Subject: **Vermont Yankee Nuclear Power Station**
Technical Specification Proposed Change No. 263 – Supplement No. 14
Extended Power Uprate – Response to Request for Additional Information

RELAP5 Nodalization Diagram

FIGURE
Vermont Yankee NSSS RELAP5 Model

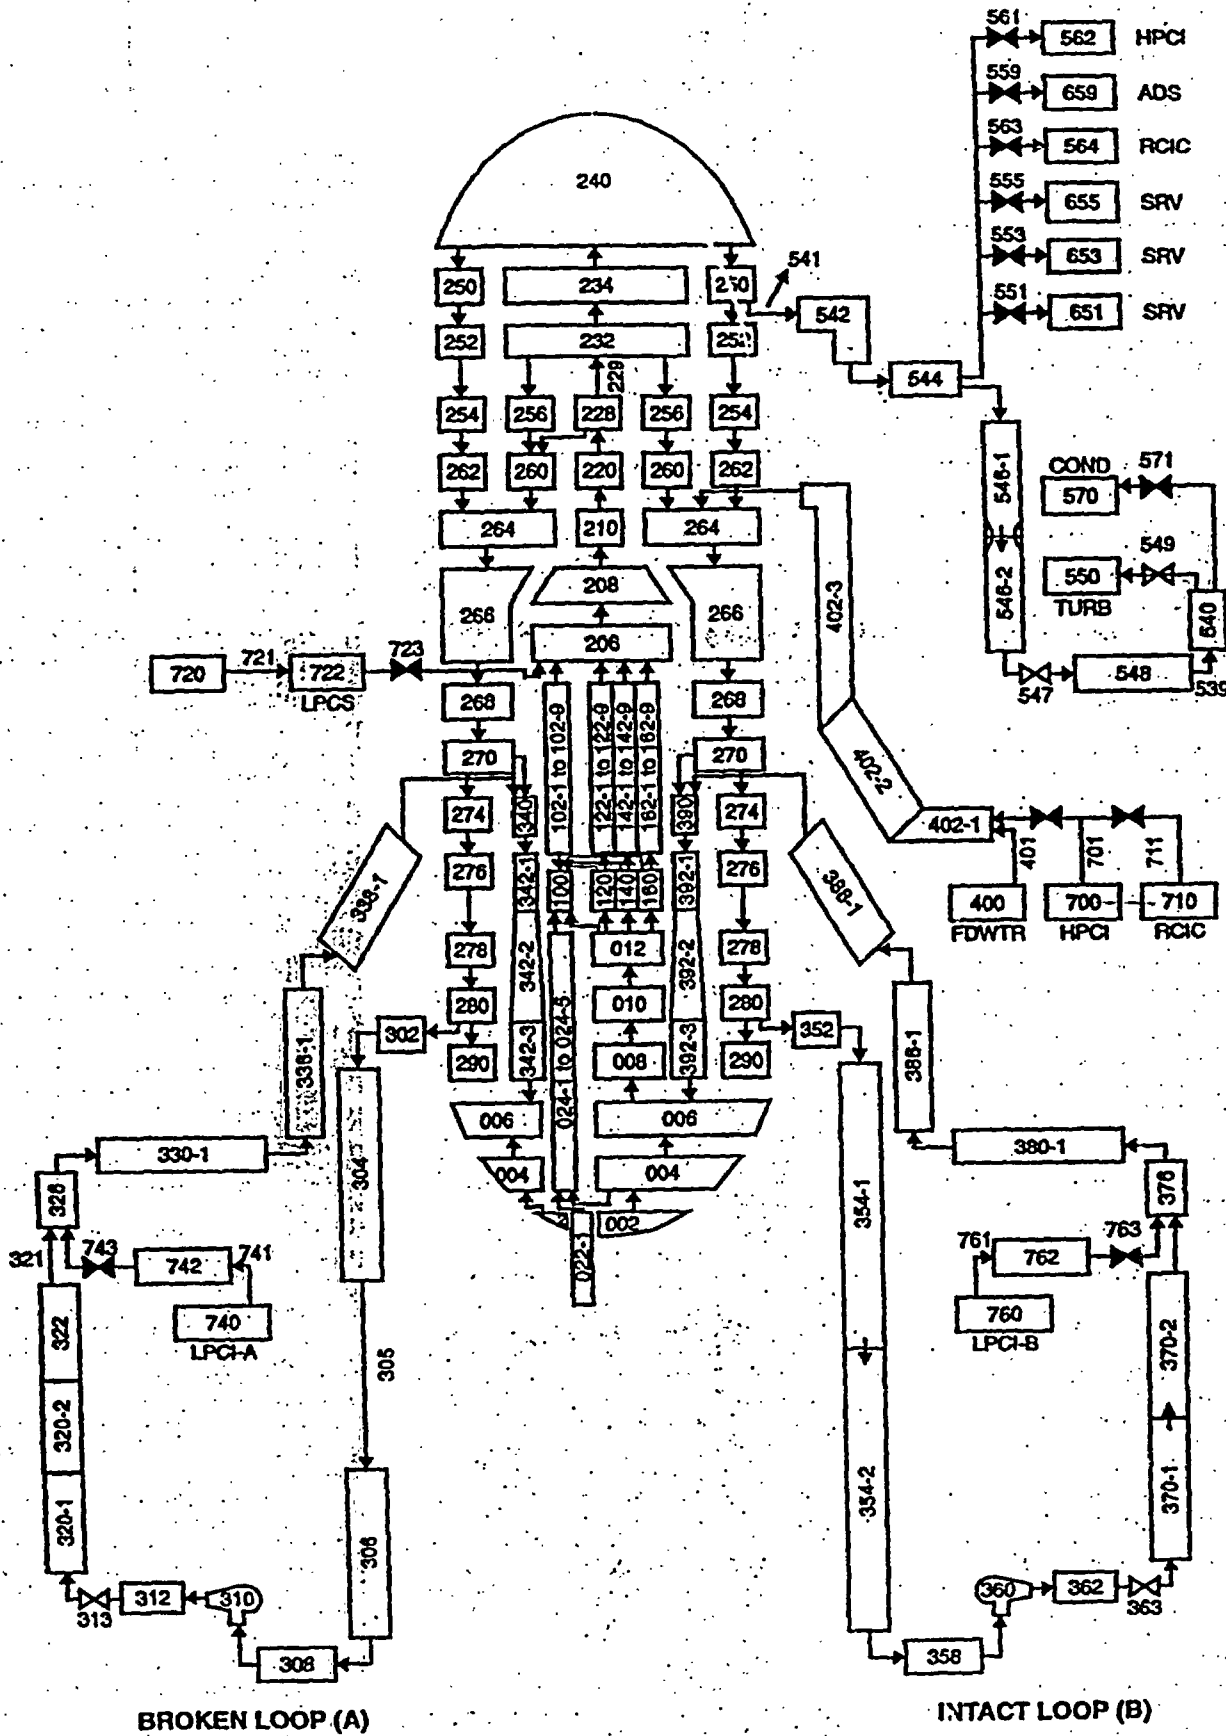
Attachment 1 is a RELAP5 nodalization diagram representation of the VYNPS nuclear steam supply system.
